**SUNSHINE CANYON LANDFILL – COMMUNITY ADVISORY COMMITTEE  
CITY & COUNTY OF LOS ANGELES**

**RE: Response to request for comments on the Scope of Work, Ambient Air Quality  
Monitoring Program at SCL and Van Gogh Elementary School.**

## SCL-CAC Additions/Edits to the proposed Scope of Work

**Figure 1.** View of Sunshine Canyon Landfill and the surrounding monitoring stations (triangles): Sunshine Canyon Landfill (LS), Sunshine Canyon Landfill North (LN), and Community site (CS).

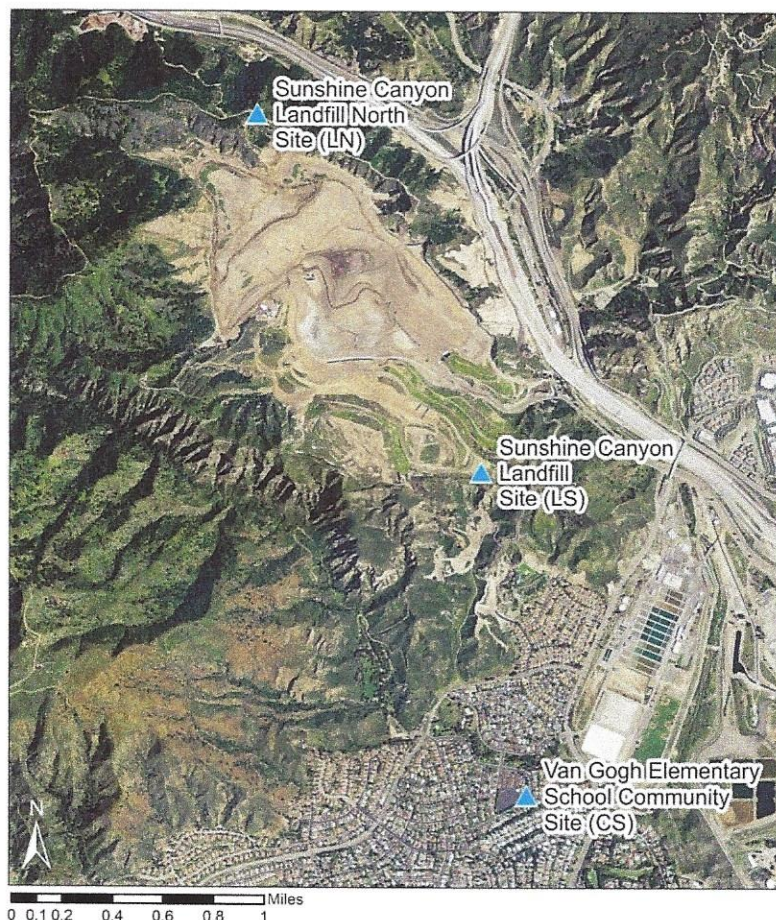
Further, that the “amendments” indicated should be made to include a third sampling site LN located to the north and upwind of the landfill (as was included in the original contract) in order to accurately quantify the landfill’s contribution to air quality impacts (see attached Introduction from 38<sup>th</sup> Quarterly Report, dated March - May 2017 for site LN location).

Consultant shall also ~~determine whether or not there is a need to~~ install air quality sampling and meteorological monitoring equipment ~~additional wind monitor~~ north of the landfill to assess landfill contributions to neighborhood-scale pollutant concentrations when the winds are from the north. Consideration of power supply source will also need to be analyzed and an installation schedule recommended by the Consultant for this additional ~~wind monitor, if necessary~~ monitoring location. Cost associated with this additional work shall be proposed as a separate line item.

All sections that reference monitoring locations (e.g., 2 and 17) in the Scope of Work should be revised, as appropriate, to reflect the inclusion of a third monitoring site.
